STAGE 3 SUBMITTAL - JULY 23, 2025

REVIEW COMPLETE

PROJECT DESCRIPTION  
THE PROJECT INVOLVES THE CONSTRUCTION OF NEW SIDEWALKS ON BOTH SIDES OF SPRINGDALE ROAD FROM POOLE ROAD TO YELLOWWOOD DRIVE.

PROJECT ID  
120861

SPRINGDALE ROAD

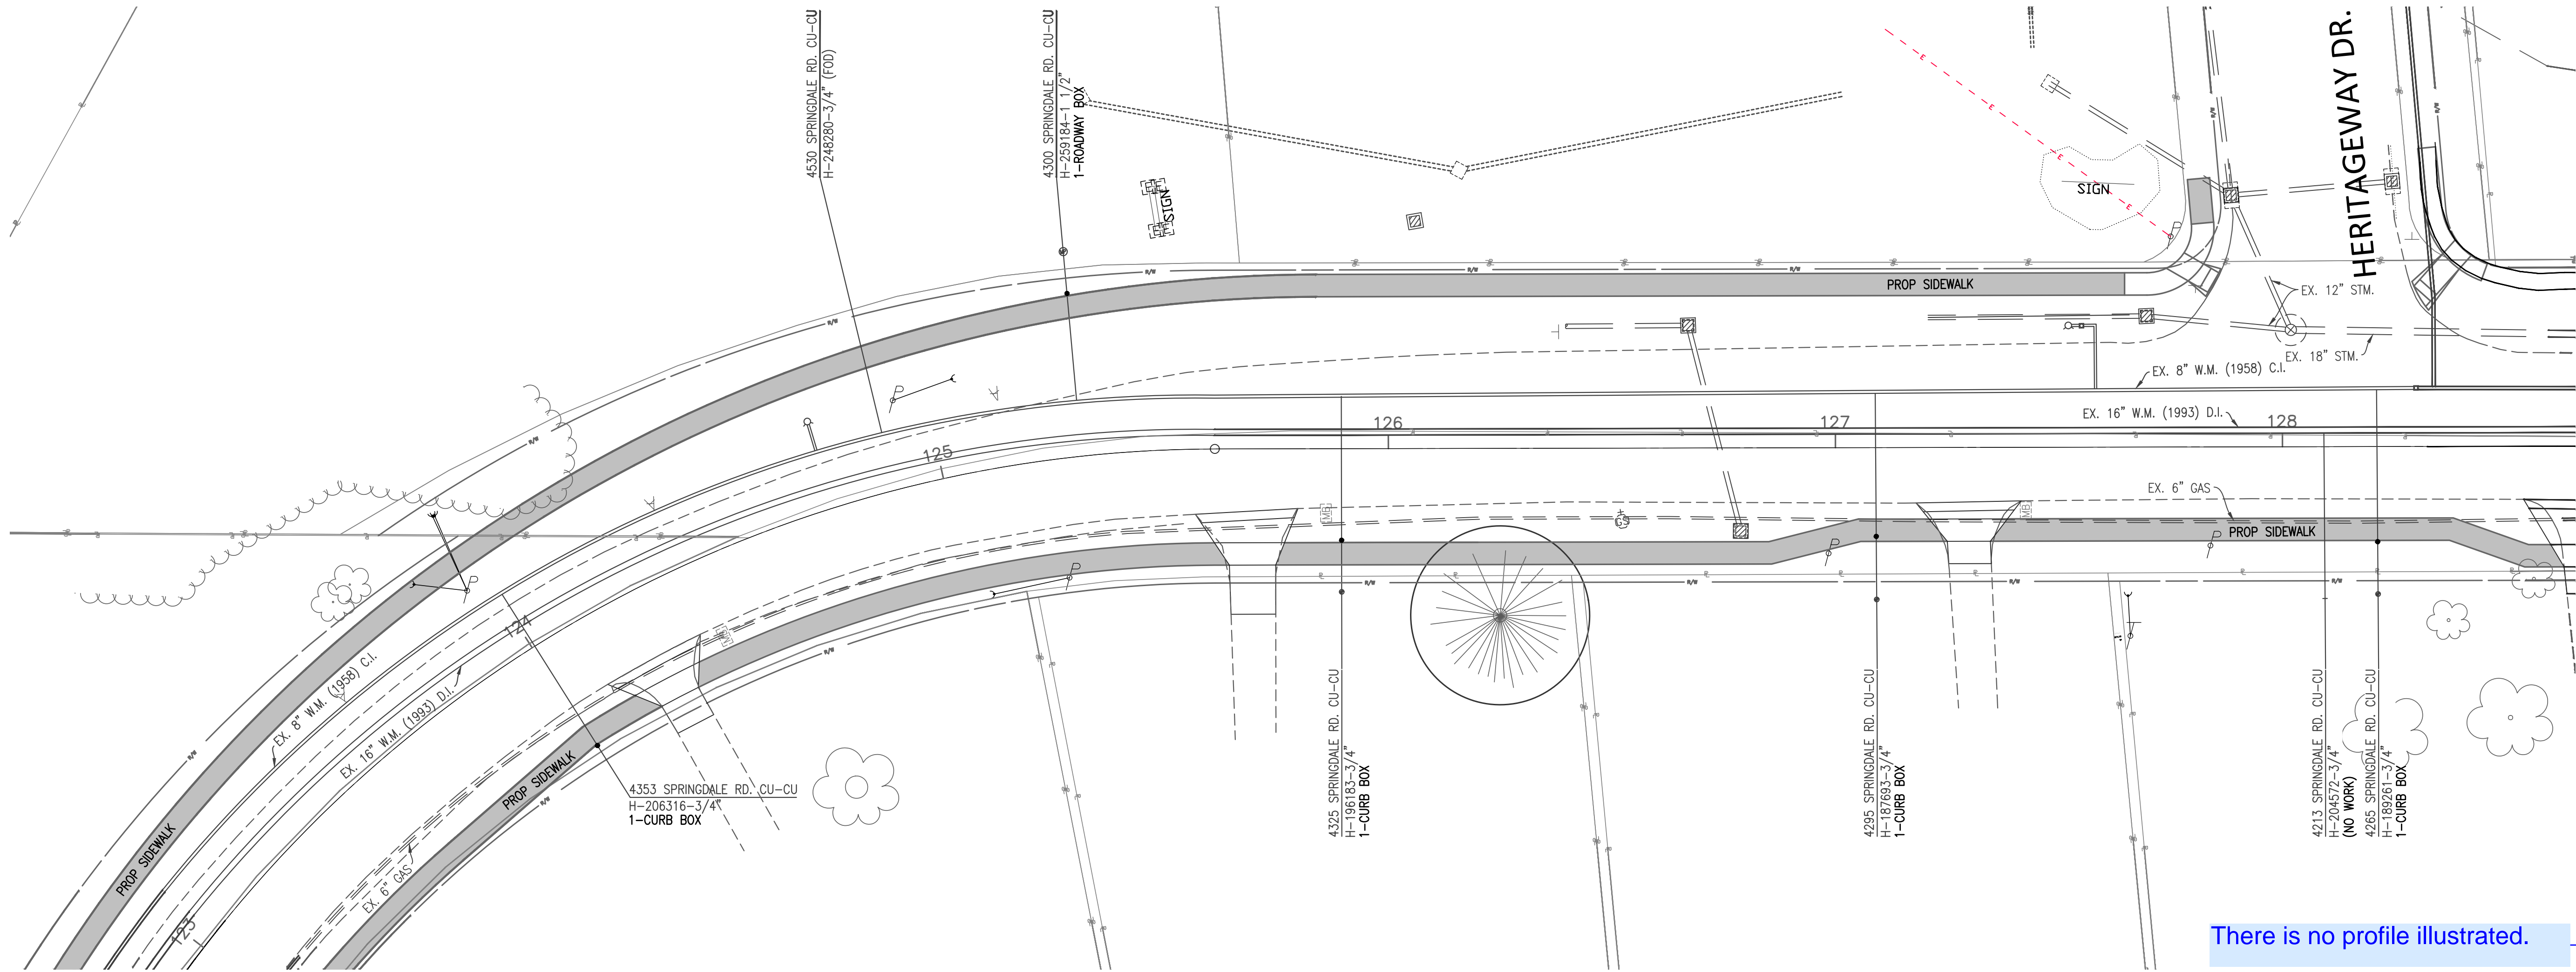
There is no profile illustrated.
